STOCKTON UNIFIED SCHOOL DISTRICT

Expanded Learning Opportunities Program (ELOP) - Relocatable Classroom Buildings

The following additions, deletions and revisions to the plans, specifications and Addenda shall become a part of the plans and specifications. It is the responsibility of the General Contractor to submit the information contained in this addendum to all subcontractors and suppliers. The Bidder shall acknowledge receipt of the Addendum in the Bid Proposal. (Addendum number of pages: **32** pages + **77** attachments = **109** total pages).

AD1-ROO
-A202

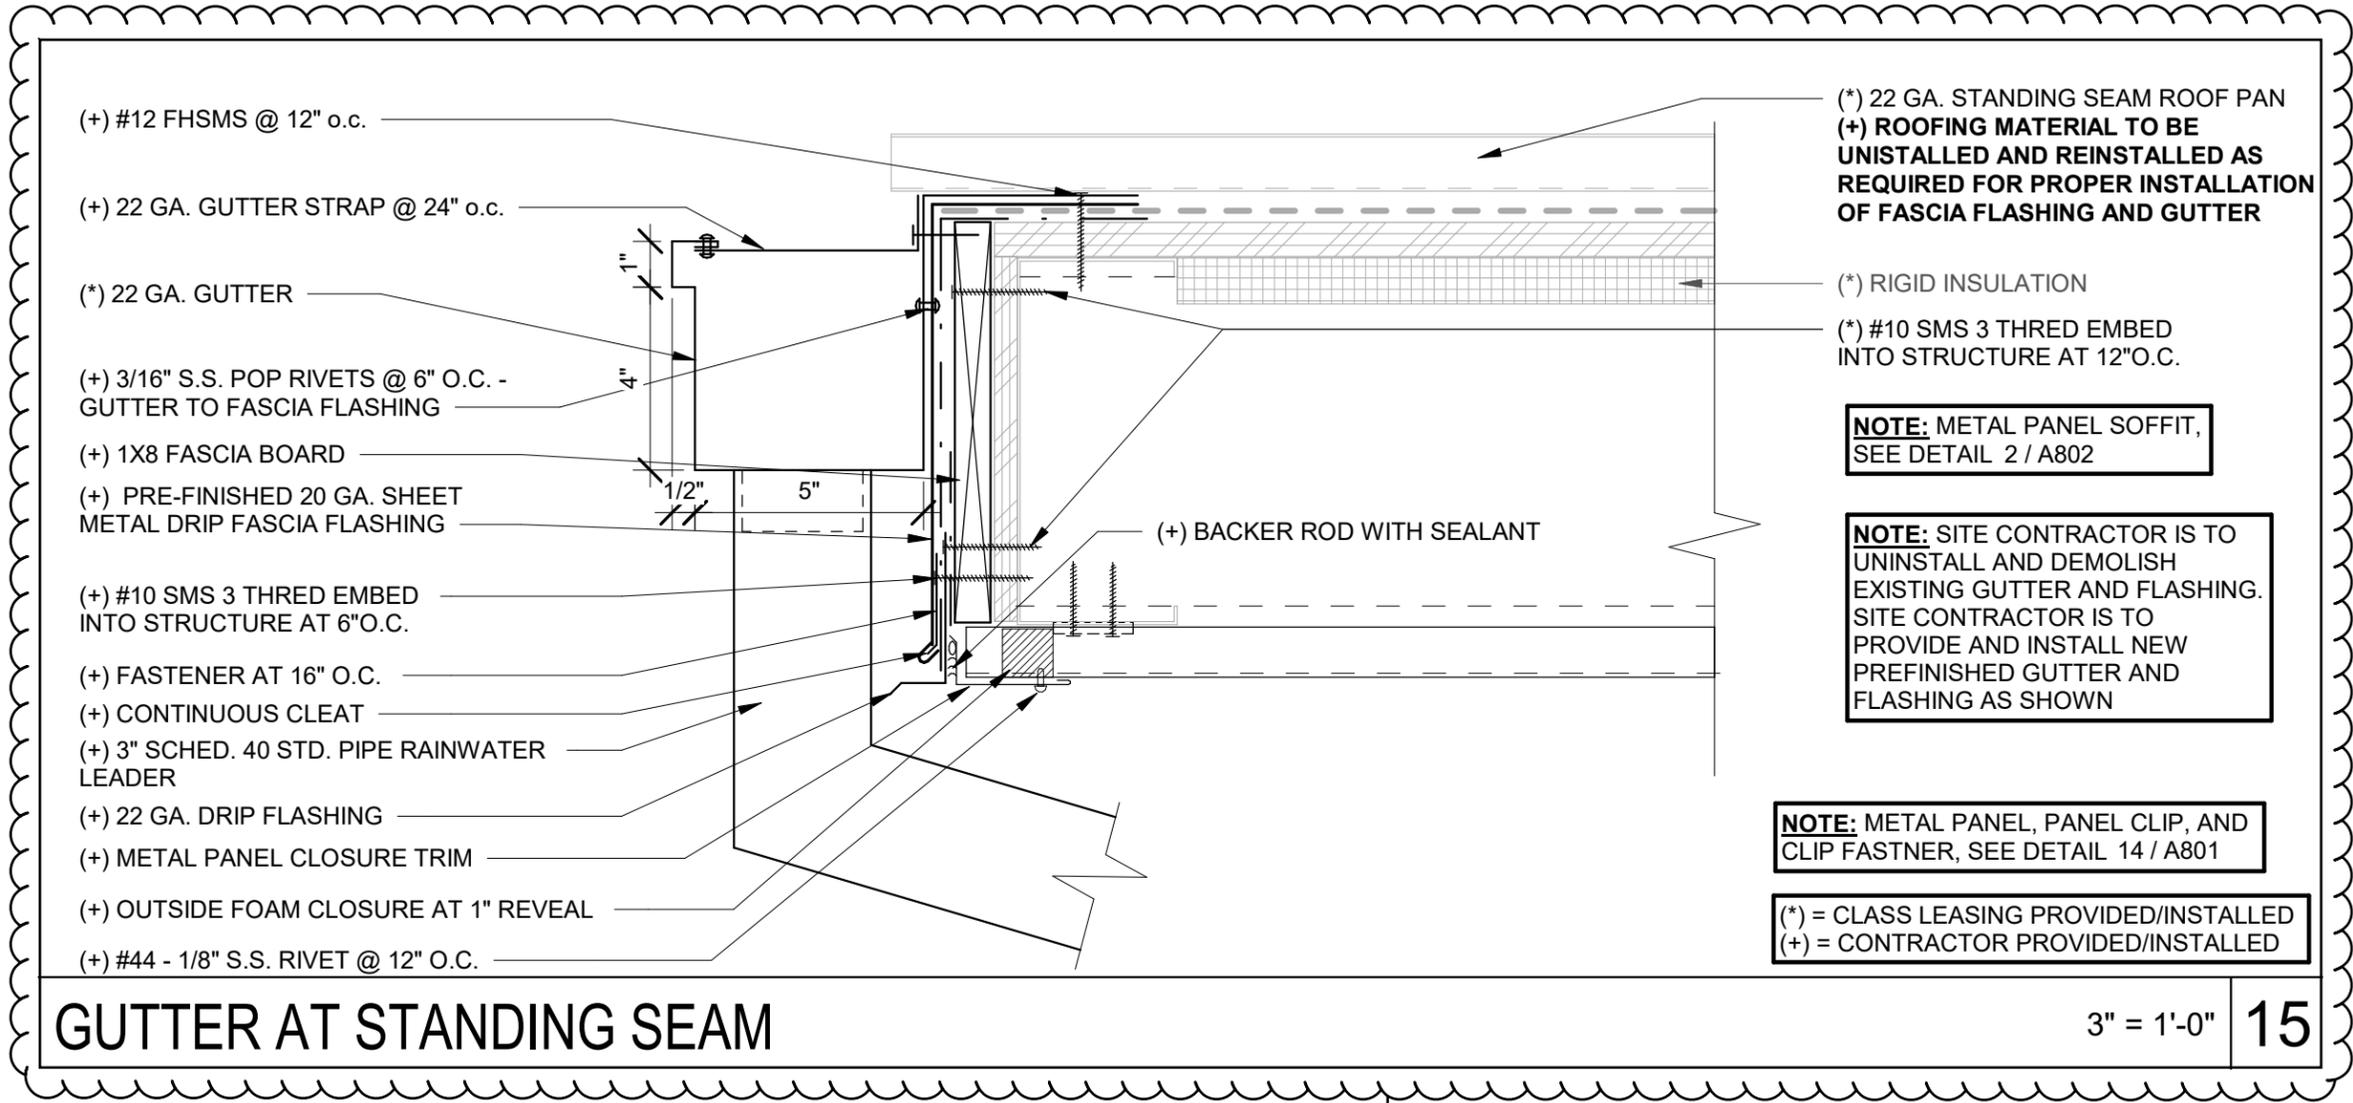
1 - 060: DRAWINGS SHEET A202 - “VENTING FLOOR PLANS”, revise as follows:

A. Per attached drawing **AD1-ROO-A202**.

1. Reflected ceiling plan – Perforated panel venting has been added.
2. Foundation plan - Vent dimensions have been revised.

JOB NUMBER:
23-12902
 DWG. DATE:
02/20/25
 AD1-ROO
 -A801

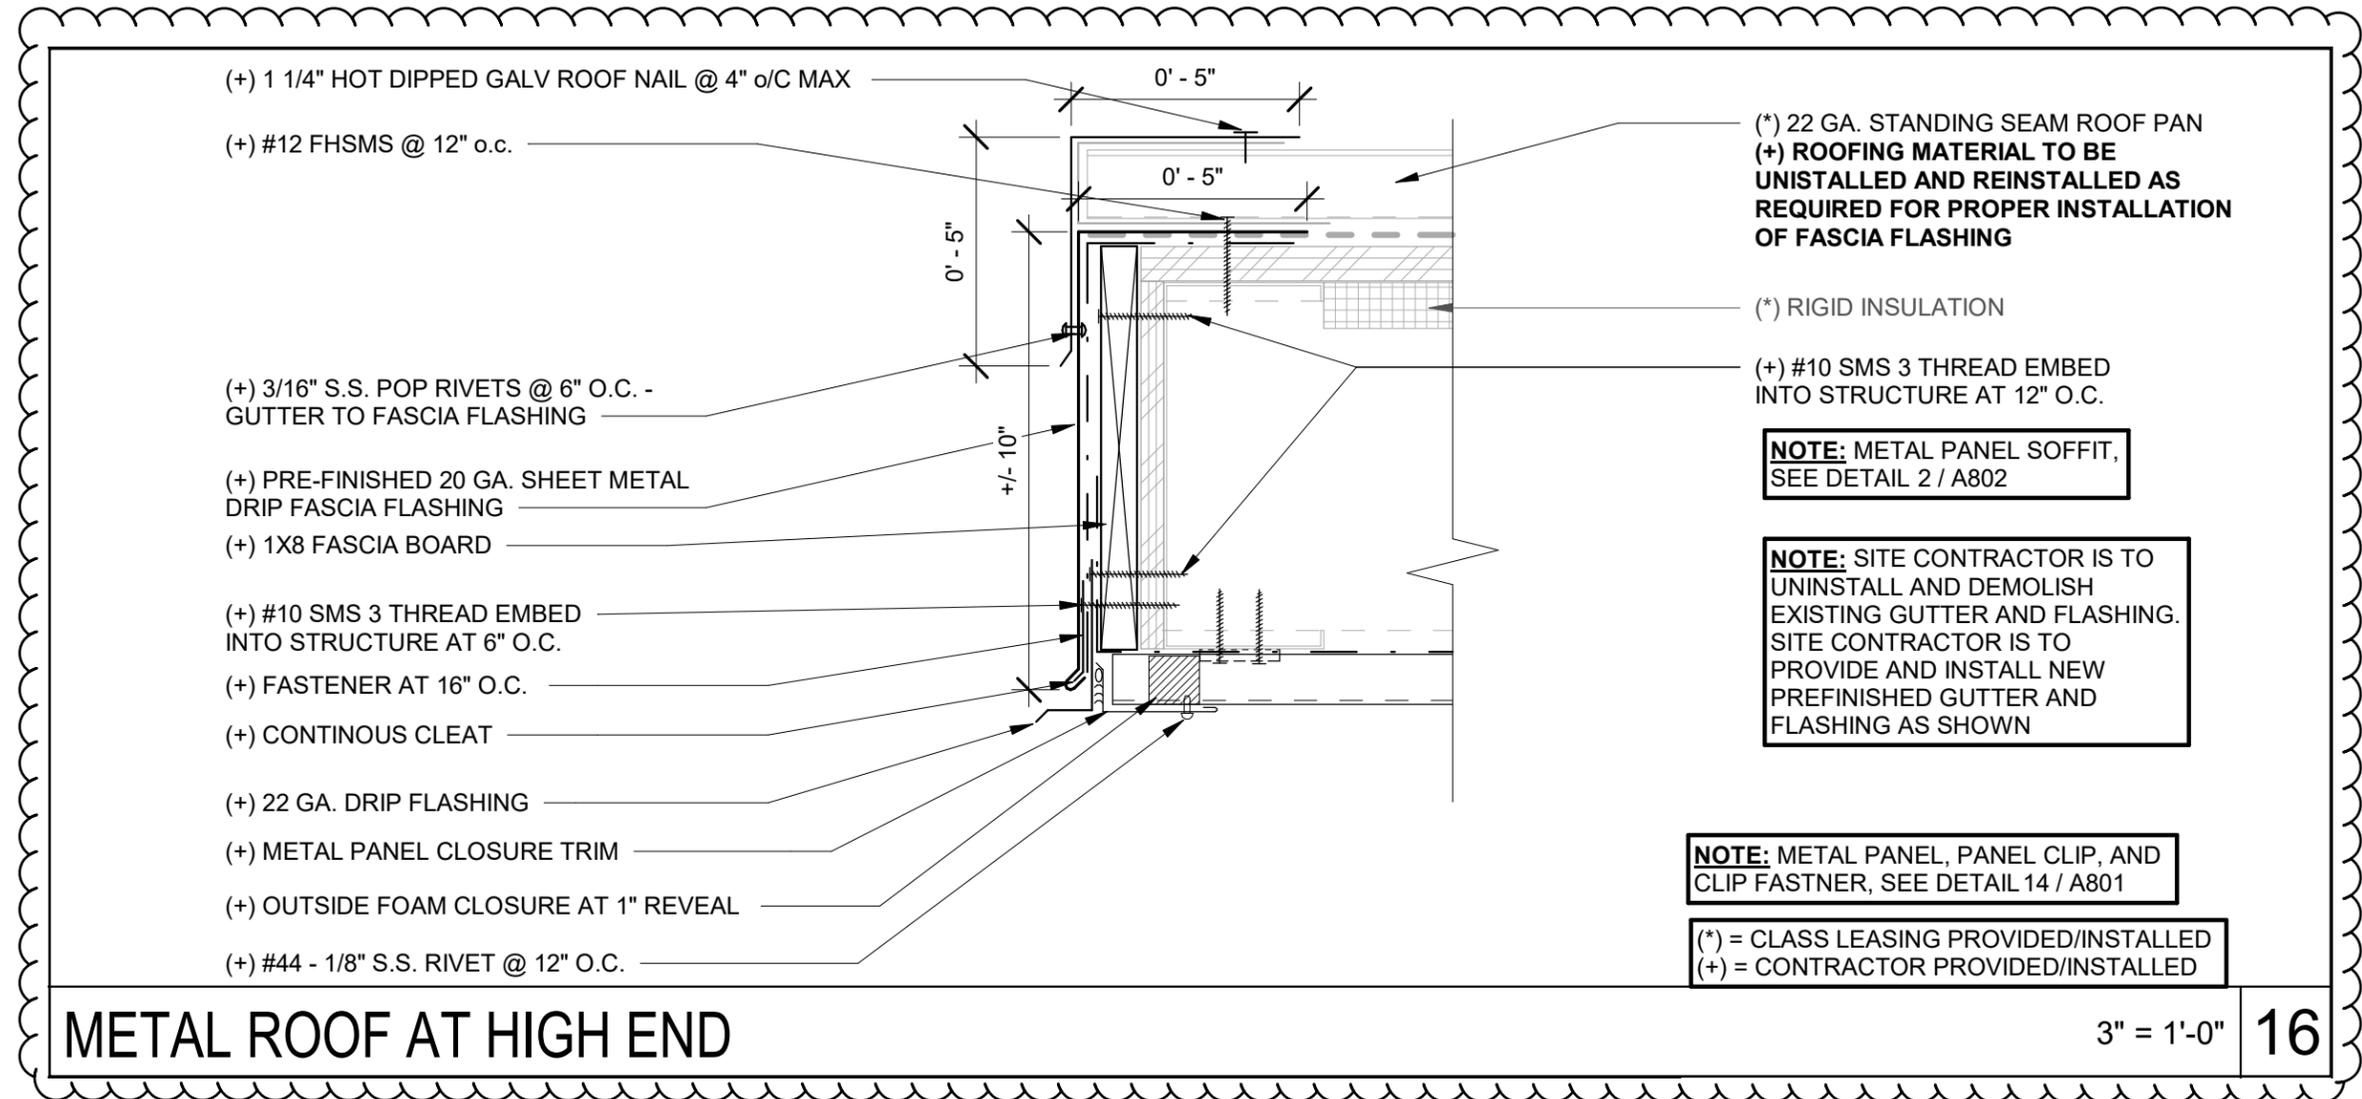
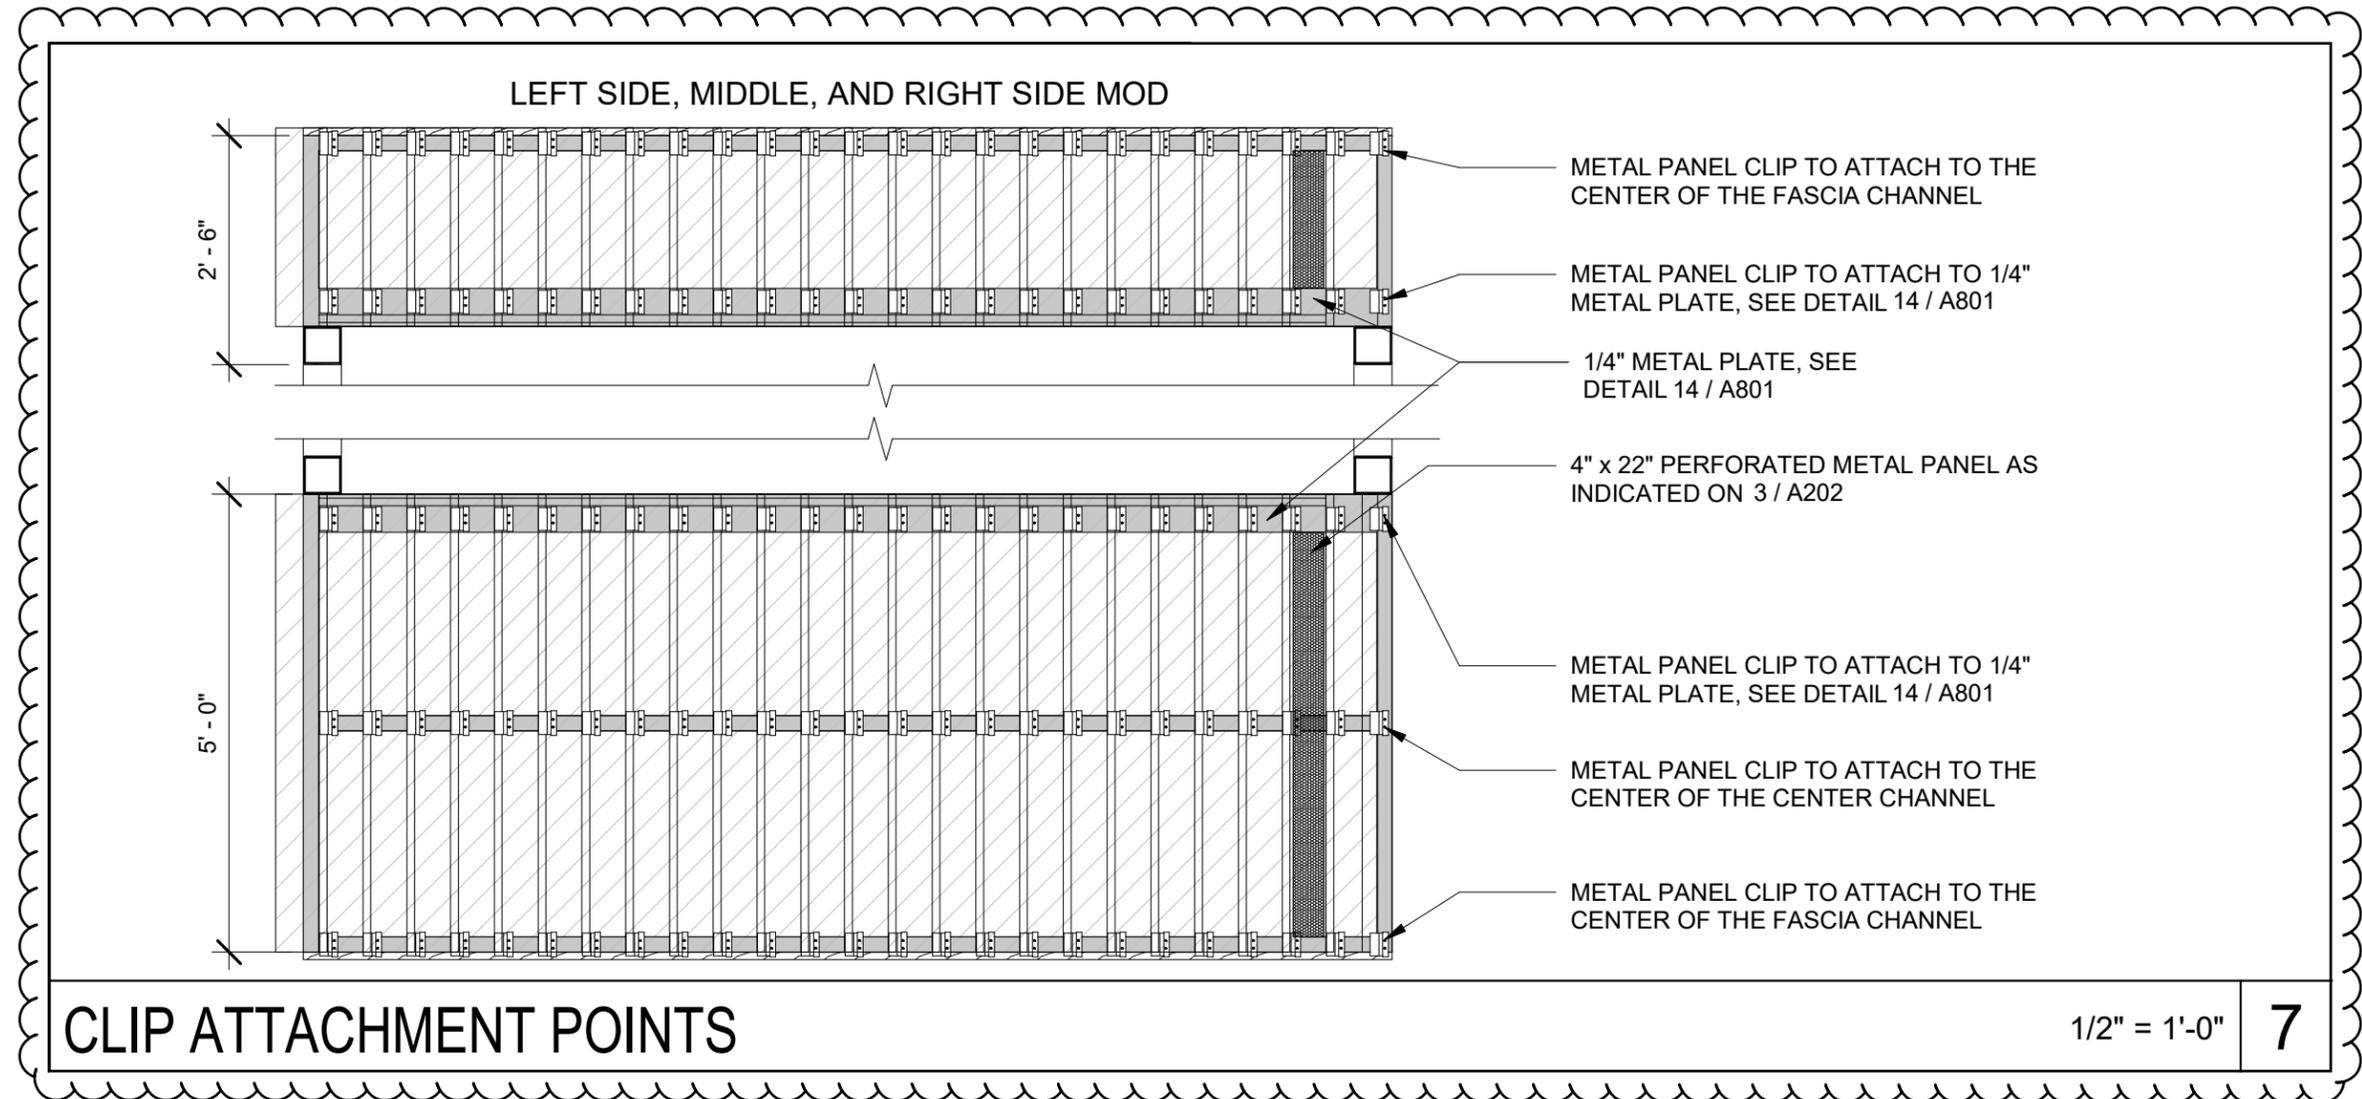
1 - 061: DRAWINGS, SHEET A801 - “EXTERIOR DETAILS”, revise as follows:

A. Detail 14 – Clip fastener note revise to “(2) #12 SMS w/3 THRED INTO STRUCTURE PER CLIP”

B. Per attached drawing **AD1-ROO-A801**

1. Detail 15 and 16 - Additional fastener information has been provided.
